**GEORGETOWN-SCOTT COUNTY PLANNING COMMISSION
AGENDA**

**August 13, 2015
6:00 p.m.**

CNG FUEL STATION
Staff Report to the Georgetown-Scott County Planning Commission
August 13, 2015

GOLF TOWNHOMES OF CHERRY BLOSSOM, PHASE 5
Staff Report to the Georgetown-Scott County Planning Commission
August 13, 2015

1 SITE PLAN
SCALE: 1" = 20'

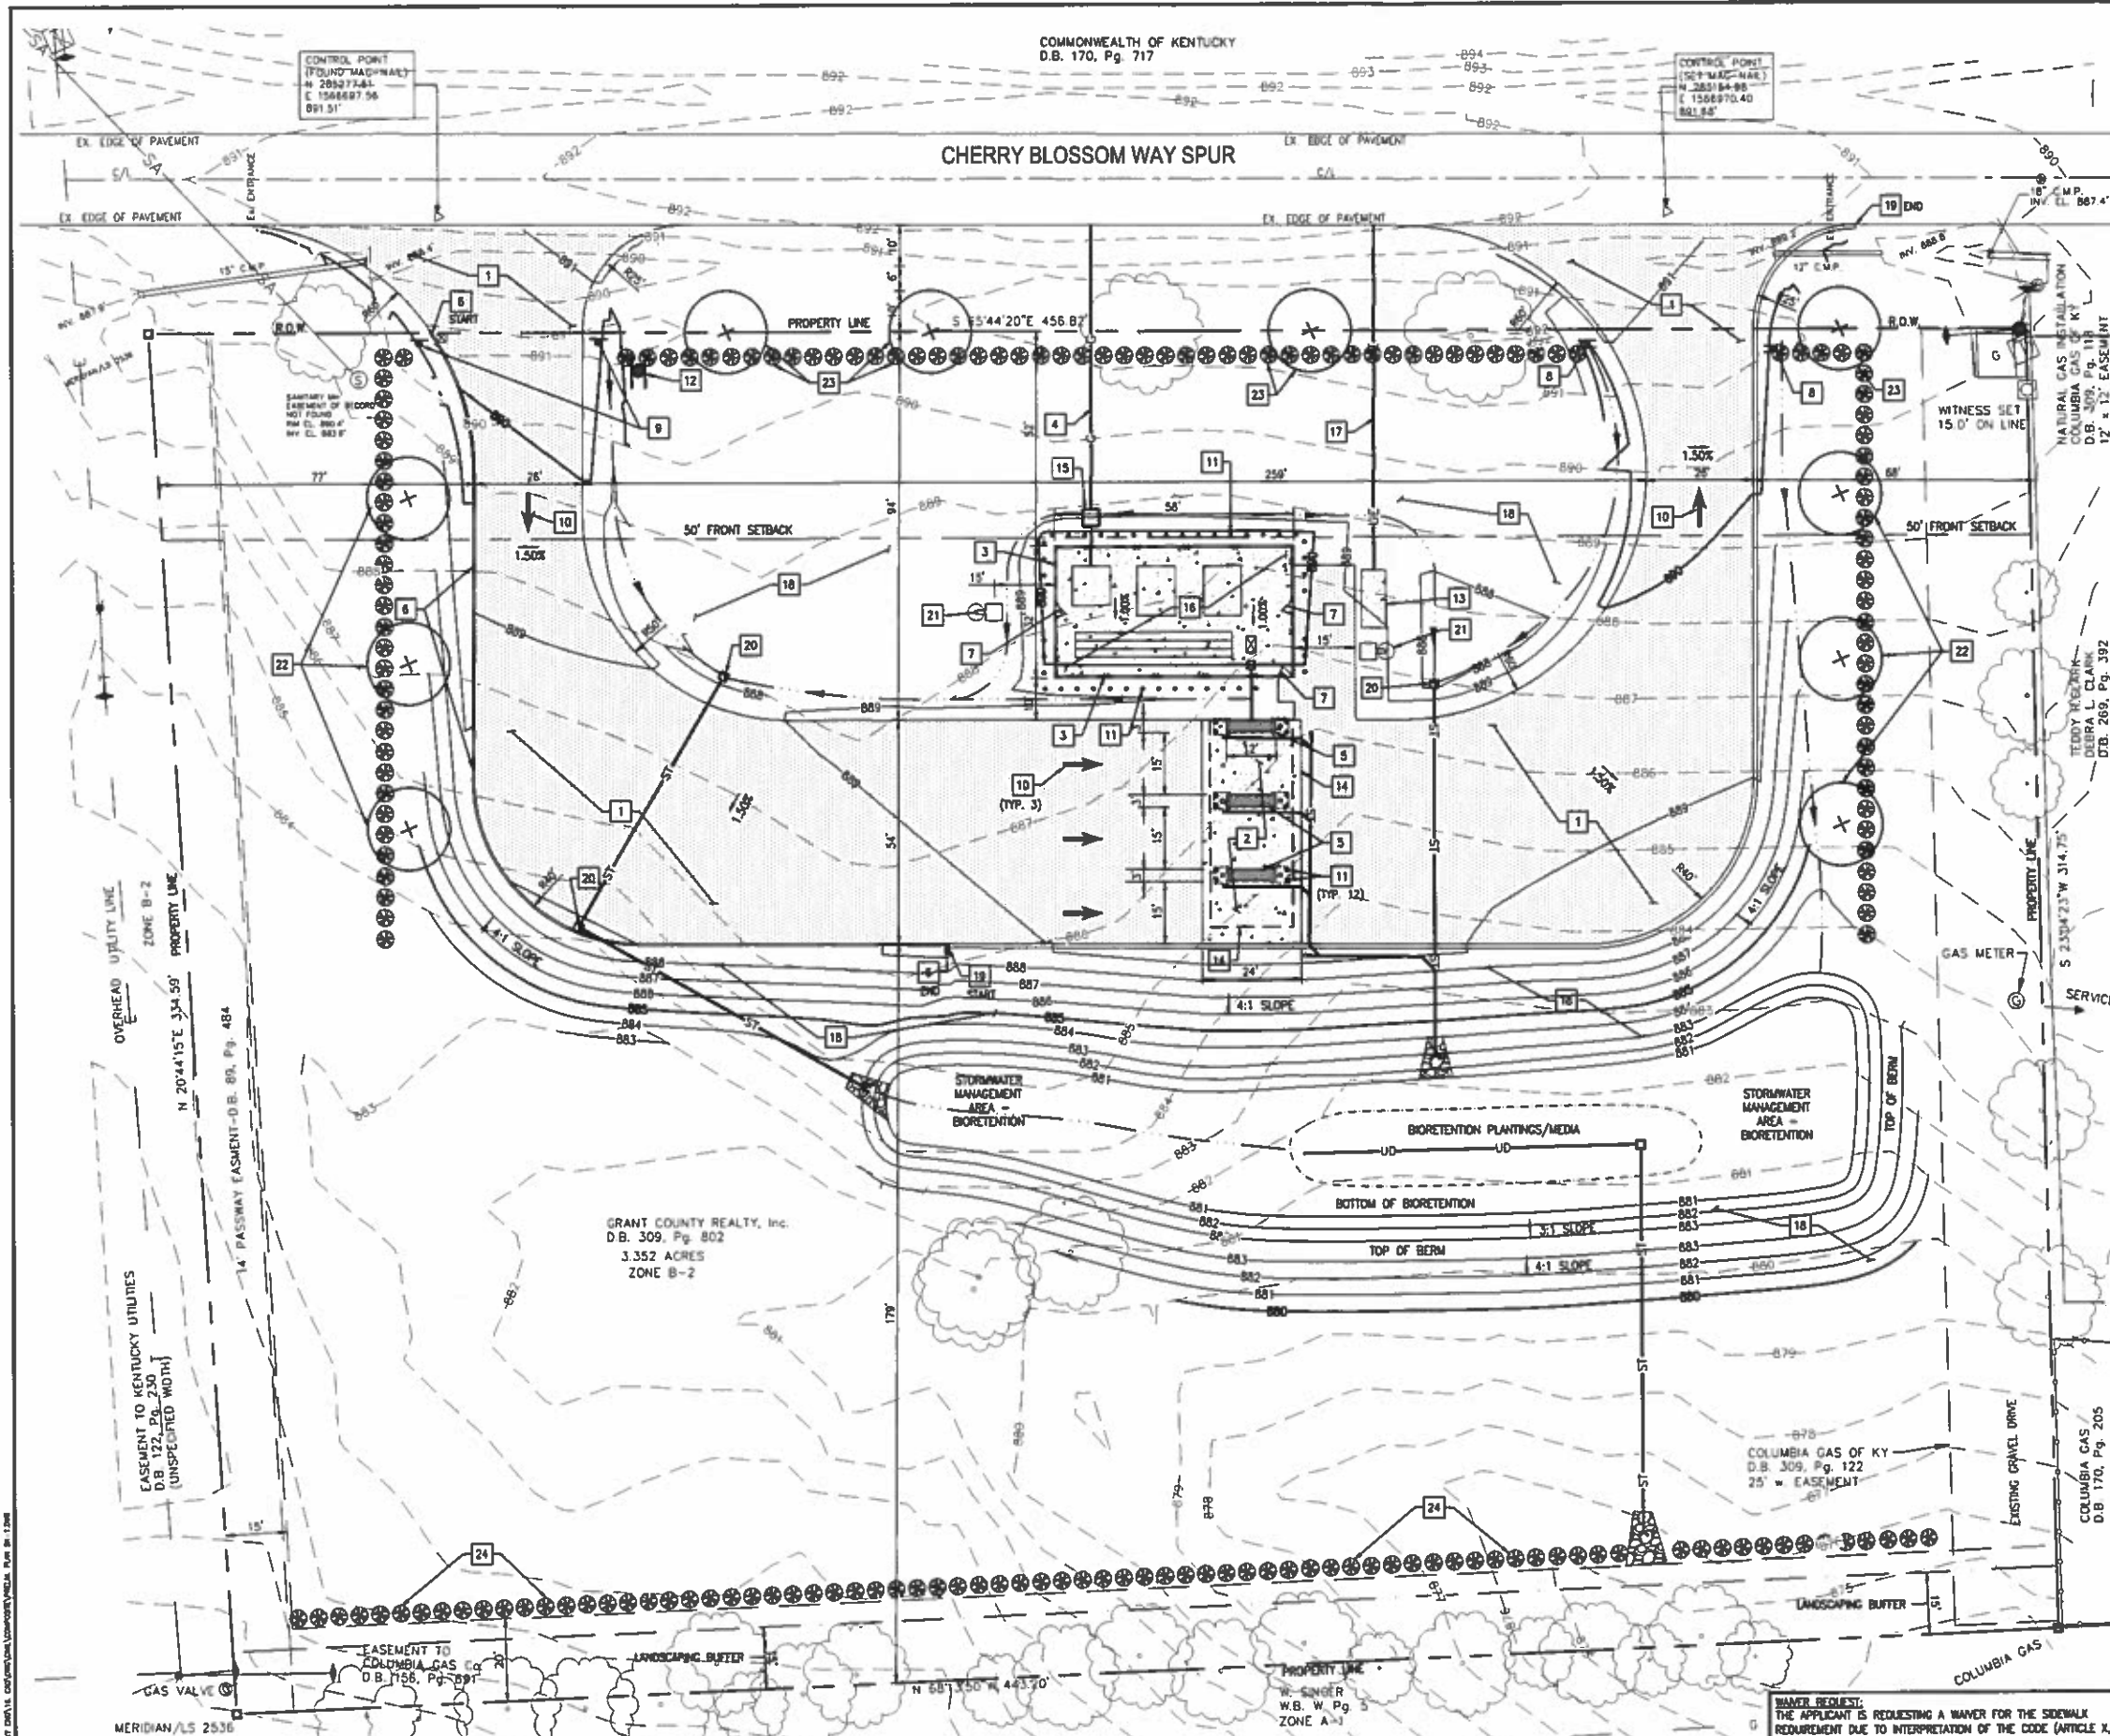
The Applicant is proposing 26,090 SF VUA, which would require 2,609 SF of interior landscaped area and 11 interior trees. Given the proposed land use, and design of the site, it does not make sense to force the Applicant to install landscaped islands or peninsulas. Staff does recommend the Planning Commission grant the Applicant a waiver to plant the required interior trees elsewhere on the project site. There are many areas south of the VUA where the Applicant could easily fit the required 11 trees. Staff also recommends the Planning Commission waives the requirement for interior landscaping area on the project site.

provide 12% canopy coverage through the planting of new trees. Planting the ten trees shown on the development plan will only provide roughly 11% canopy coverage. If the Planning Commission requires the Applicant to plant the 11 trees discussed in the previous paragraph, the Applicant will have provided more than enough trees to satisfy the canopy requirements of the Landscape Ordinance.

Staff recommends **Approval** of the Preliminary Development Plan for the construction of a CNG vehicle fueling station on the 3.352-acre lot. As part of that approval, staff suggests that the Planning Commission attach the following waivers and conditions:

2. All applicable requirements of the *Subdivision & Development Regulations*.
3. All applicable requirements of the *Zoning Ordinance*.
4. The Applicant shall provide a lighting and photometric plan along with the Final Development Plan. Lighting shall be directed away from adjoining property and not have any off-site impact.

6. The Final Development Plan will require a species specific landscape plan.
7. A Final Stormwater Management Plan must be submitted and approved by the Planning Commission Engineer prior to approval of the Final Development Plan.

PRELIMINARY SUBDIVISION PLAN AND
 PRELIMINARY DEVELOPMENT PLAN
GOLF TOWNHOMES OF CHERRY BLOSSOM
 PHASE 5
 GEORGETOWN, SCOTT COUNTY, KENTUCKY

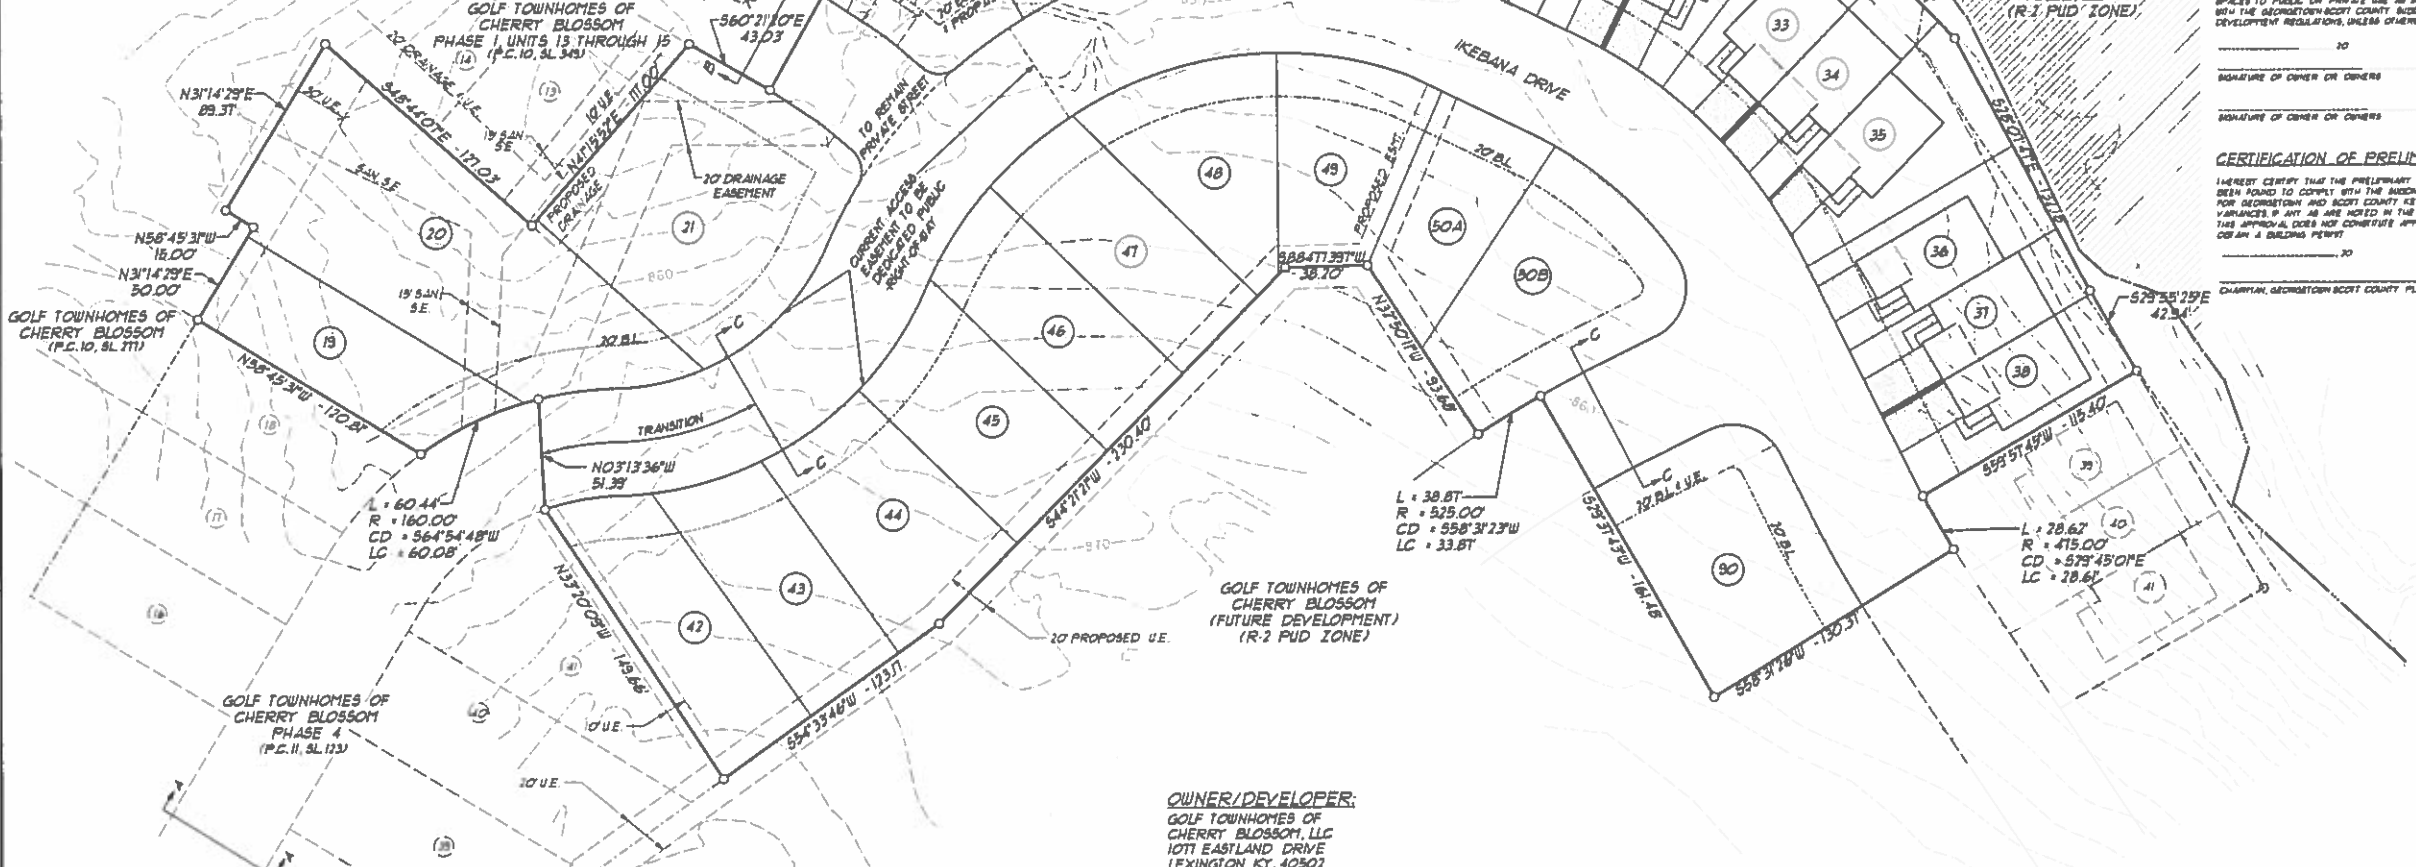
The Preliminary Plat submitted contains fourteen lots, and the Preliminary Development Plan contains fifteen attached triplex townhome units. The lots are on average 50-feet wide and conform to the density and area allowed under R-2 PUD zoning. A front yard setback variance from 30 to 20 feet is being requested on both the lots and the triplex townhomes. Approval of the front yard setback would be in keeping with what has been built in the earlier phases. The townhomes are similar in size and layout to the townhomes built on Shadow Creek Path. Parking is being provided in front loading two-car garages. Sidewalks are shown on both sides of all public streets. The single-family/duplex lots also require a variance to the lot width and area requirements for the R-2 district. Earlier phases maintained a minimum 50' lot width and it is recommended this minimum continue for all single-family lots in this and subsequent phases. All the lots proposed, with the exception of lots 19, 42 and 50A are 50' in width or wider at the building envelope.

The development is a Planned Unit Development, so adherence to the underlying zoning setback requirements is flexible as long as the change does not adversely affect the public health, safety or welfare and will not alter the essential character of the general vicinity. A reduction in the front setback would bring the front façades closer to the street and would increase the sense of enclosure of the street appropriate for an urban location. It would match the front setbacks of the townhomes on Riviera and the homes and duplexes on the built portions of Ikebana. A reduction of the front setback would render the smaller, urban-scale lots more usable and not alter the general character of the area.

Stormwater will be handled through an area wide stormwater plan and easements are shown on this plan. The stormwater management plan shall be approved by the Planning Commission Engineer. A homeowners association will be required for the maintenance of common areas and facilities.

1. Reduction of the front setback from 30 feet to 20 feet.
2. Reduction of the minimum width for single-family lots to 50' at building envelope.
3. Reduction of minimum lot area for single-family lots to 5,000 sf

6. All single-family lots shall be a minimum of 50' at the building envelope.
7. Prior to Final Plat approval provide the building footprints proposed on lots 20 and 21.

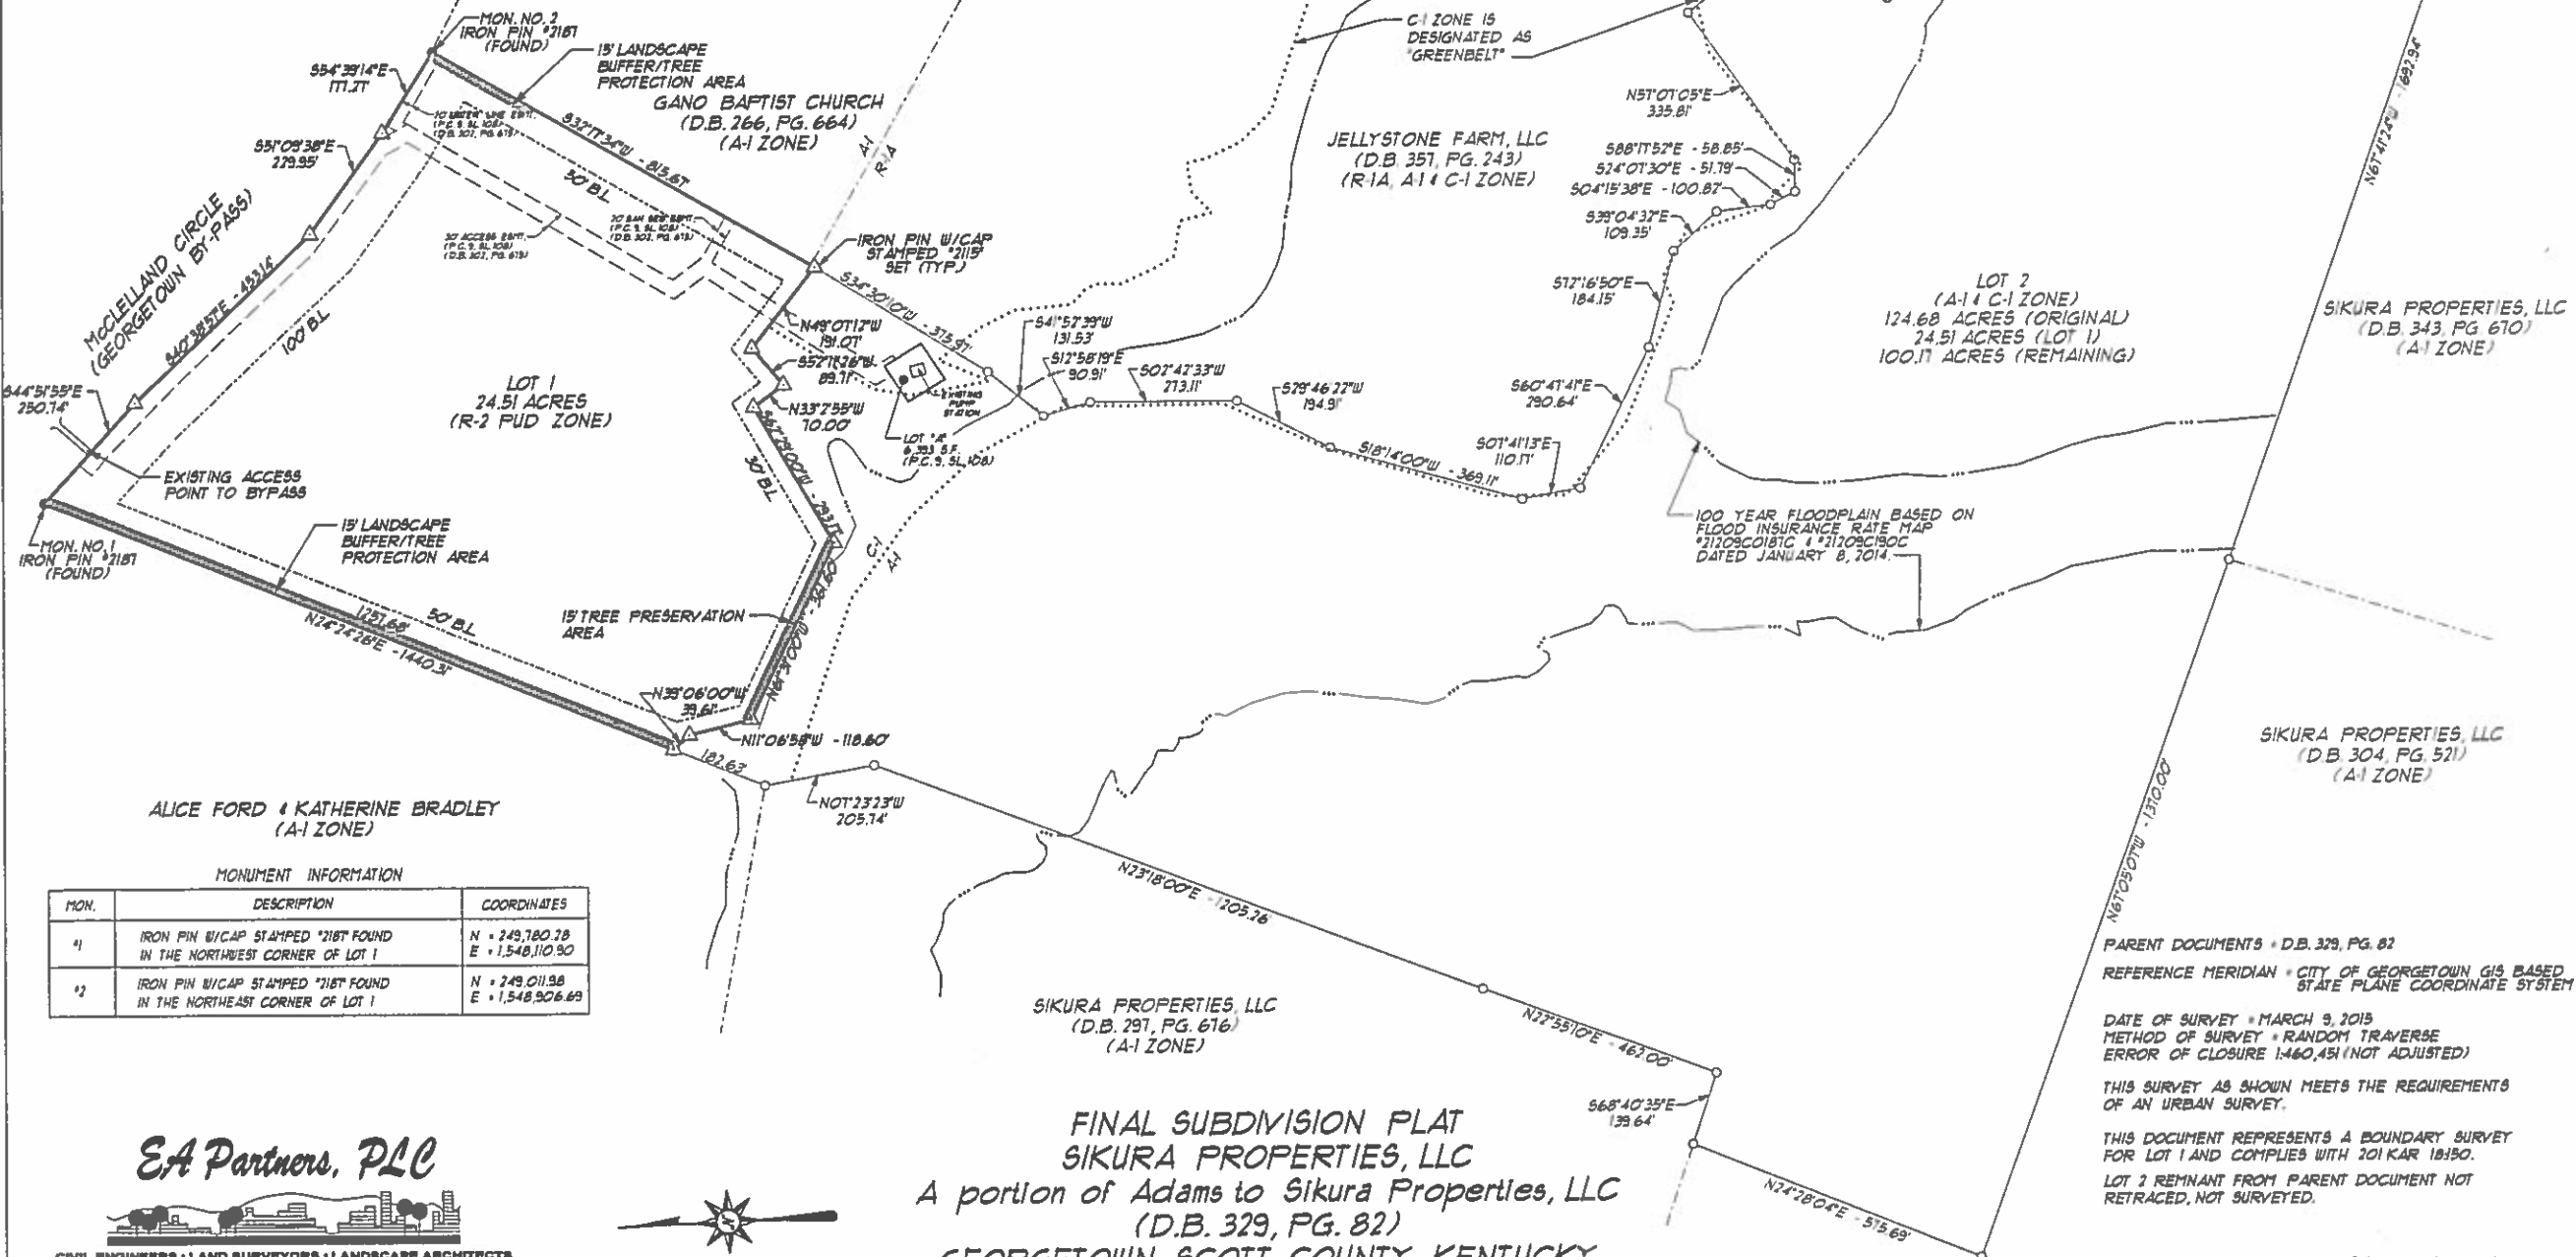
The plat shows sufficient building setbacks; 100 foot front yard along McClelland Circle (Georgetown Bypass), 50-foot side yard setbacks, and a 30-foot rear yard setback, as proposed with the concept plan submitted at the zone change. These setbacks exceed the standard R-2 setbacks, and are in place to provide additional buffering from the surrounding A-1 and C-1 properties along with the required landscape buffers.

The Applicant has shown tree preservation/landscape buffer areas on the east, south, and west property boundaries. The existing access easement to the pump station is shown. This easement will remain on lot, but may potentially be added to or removed at a later date with the final construction plans for the development of the property.

The Bradley Property is incorrectly listed in zone R-1A. The correct zoning is A-1 and will be shown on the Final Plat before recording.

1. The zoning for the Bradley Property to the west of the parcel will be updated to A-1.
2. Any future subdivisions, revisions, or amendments to the approved subdivision plat must be reviewed and approved by the Planning Commission staff (minor) or by the Planning Commission (major).
3. All applicable requirements of the *Zoning Ordinance*.
4. All applicable requirements of the *Subdivision & Development Regulations*.
5. Prior to (as part of) the Final Subdivision Plat approval, the applicant shall provide the Planning Commission staff (GIS division) with a digital copy of the approved subdivision plat.

6. A ____-foot wide easement will be shown on the project site Final Subdivision Plat for the future construction of a mutli-use trail connecting the Southern Greenbelt to the traffic signal at McClelland Circle. Location per discussion at the Planning Commission hearing.
